Hi-Fi Products
Service Bulletin

Model: TA-E1000ESD

No.113

Subject: Clicking Noise Is Heard When Changing Inputs (Sources)

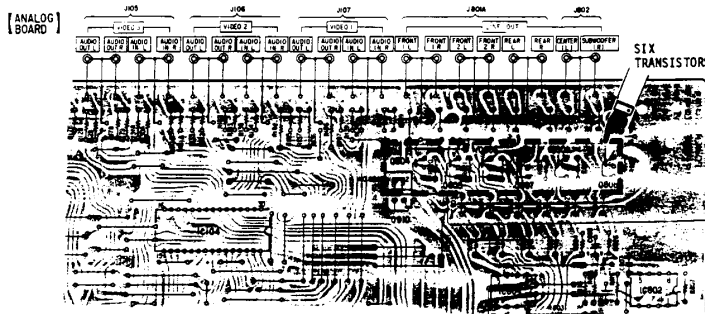
If the customer complains of hearing clicking noise through the speakers when changing inputs, perform the changes listed below. This is caused by mismatched muting transistors.

Solution: Replace the muting transistors (Q801/804-808) which are now 2SC3622 and 2SC2878B, and swap the collector and emitter leads when installing the 2SC2878B.

Ref. No.	Description		Part Number	
	Former	New	Former	New
Q801/804-808	Transistor 2SC3622	Transistor 2SC2878B	8-729-107-91	8-729-201-05
